Ontario County Public Works

Re: Fox Ridge Subdivision – Phase 5B-1

We have reviewed the plans for the above referenced project dated October 2019, received in this office on March 10, 2020 and hereby submit the following comments:

SANITARY CLEANOUT DETAIL (4" LATERAL)

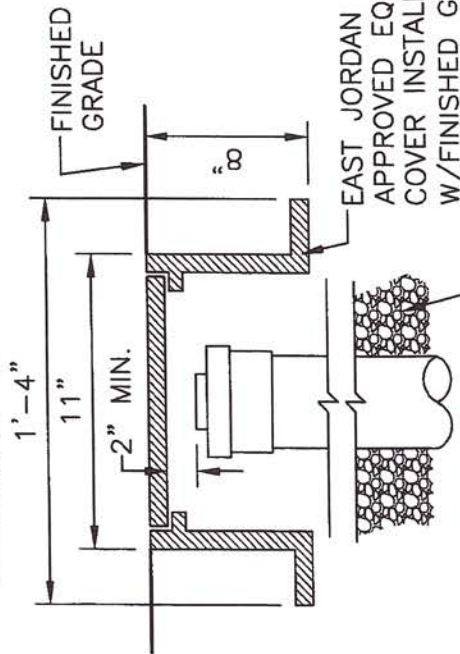
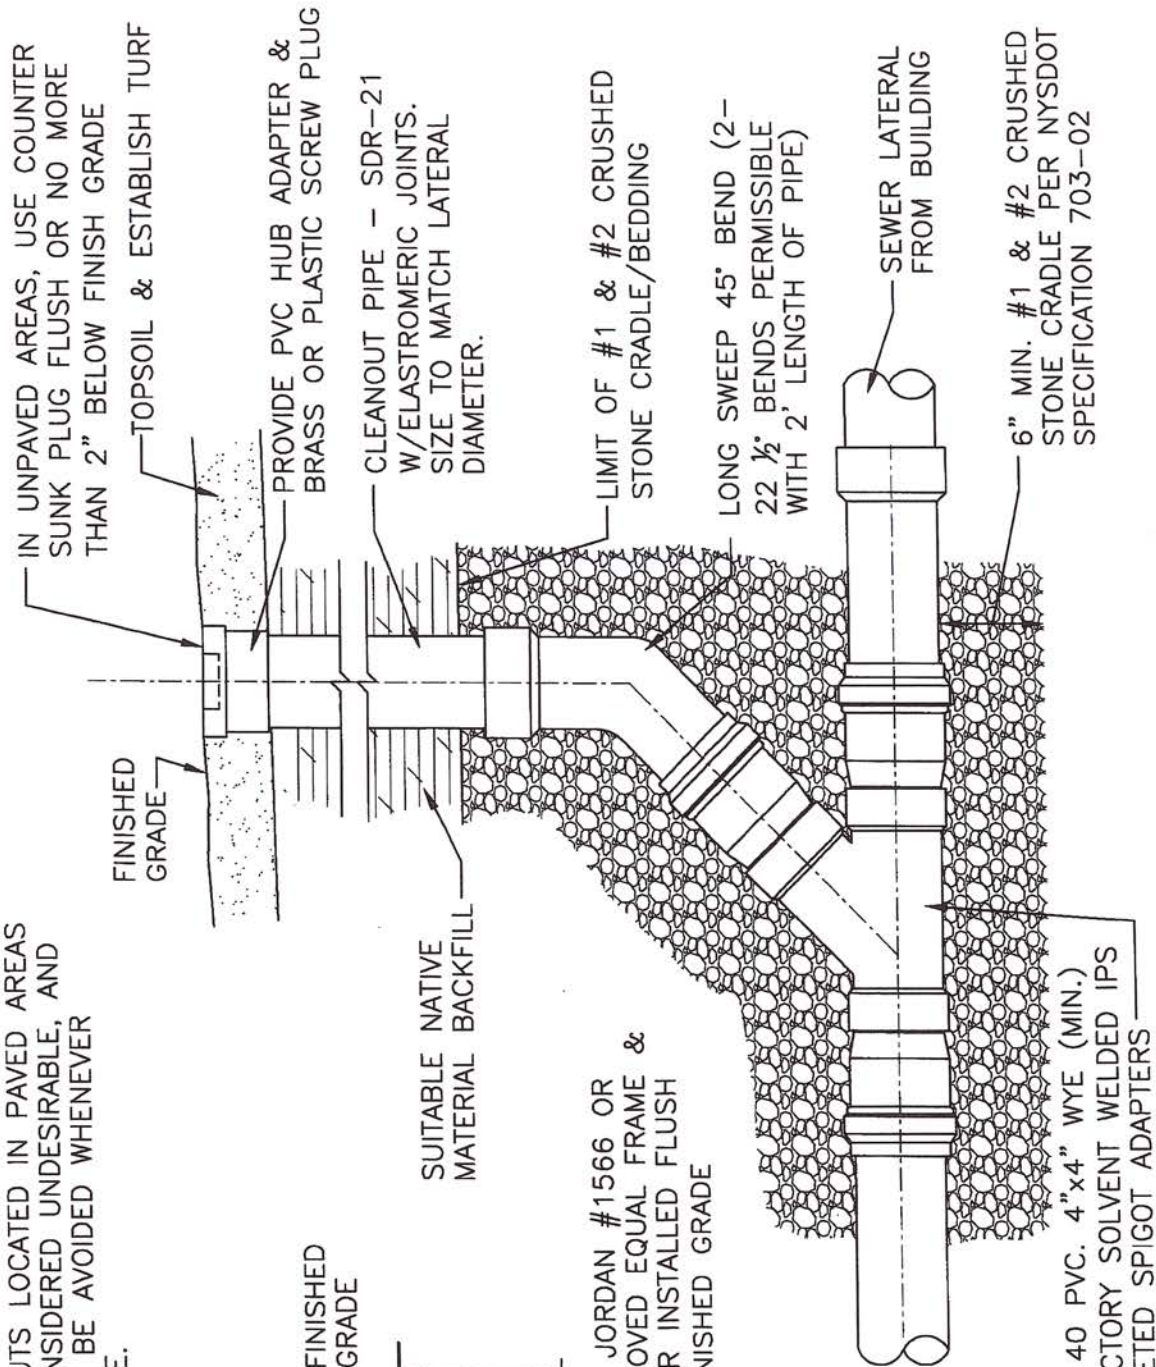
7. Increase the size of CLCSD Standard Sanitary Sewer Plan Notes to make them more easily readable.
8. Remove the Sewer Cleanout Detail and Sanitary Sewer Bedding Detail located adjacent to the sewer district sanitary sewer plan notes.
9. Replace the 6" Sanitary Cleanout Detail shown with the 4" Sanitary Cleanout Detail provided.
